Schedule 17 Plans and Specifications Design and Access Statement Addendum- Adelaide Road Vent Shaft S1

Document no.: 1MCo3-SCJ_SDH-IM-STA-SSo2_SLo1-000001

1.3 Design Development - Northern Facade

1.4 Design Development - Headhouse Dimensions

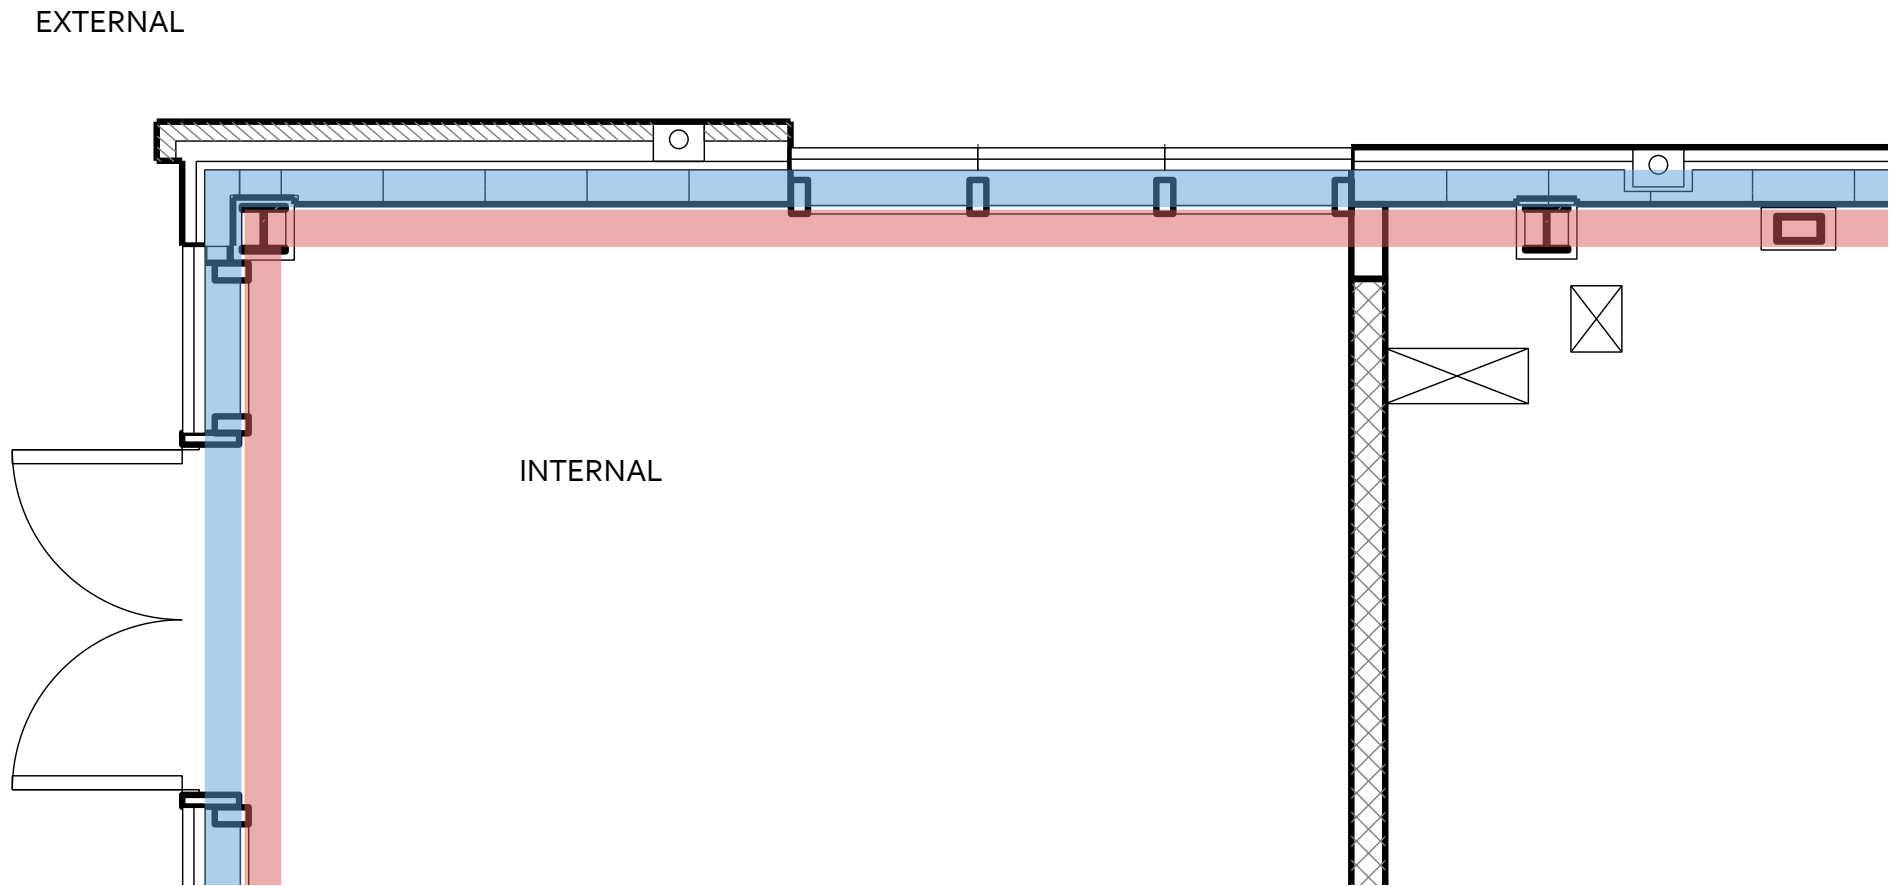
Since the original Schedule 17 submission the main building has increased in size along the northern elevation; from 40.75m to 41.15m wide, an increase of 400mm. 100mm of this increase is due to 100mm deep timber fins being applied to part of the western elevation. The remaining 300mm increase is due to the design development of the facade.

In the previous design, the steel framed wall system sat within the structural zone (indicated as red adjacent). Additional space was required within the building for equipment and it was decided to push the wall finishes by 150mm to sit outside the structural zone (indicated as blue adjacent), providing extra space inside the building with a minimal increase to the footprint.
